Product Change Notification / LIAL-230THC778

CCB 3700.006 Final Notice: Qualification of a new fabrication location TMGR of component U5 that is one of many components of the ATSAM5D27-WLSOMxx device family available in the 188L module (40.8x40.8x3.3mm).

U5 Component Location

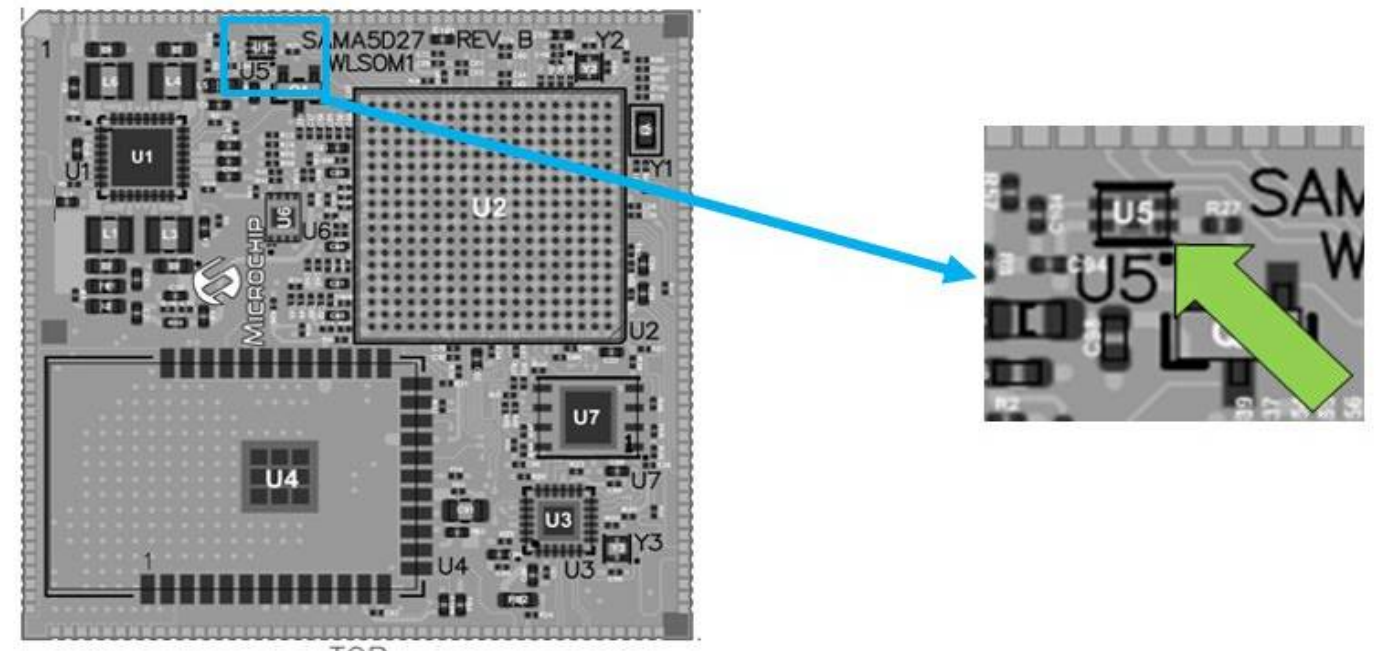
Description of Change:Qualification of a new fabrication location TMGR of component U5 that is one of many components of the ATSAM5D27-WLSOMxx device family available in the 188L module (40.8x40.8x3.3mm). Please see attached to reveal the location of the component U5 on the module.

Pre Change	Post Change
Fabrication Site	Micrel Inc. (MCRL)	Microchip Technology Tempe – Fab 2 (TMGR)
Wafer size	6 inch wafers	8 inch wafers
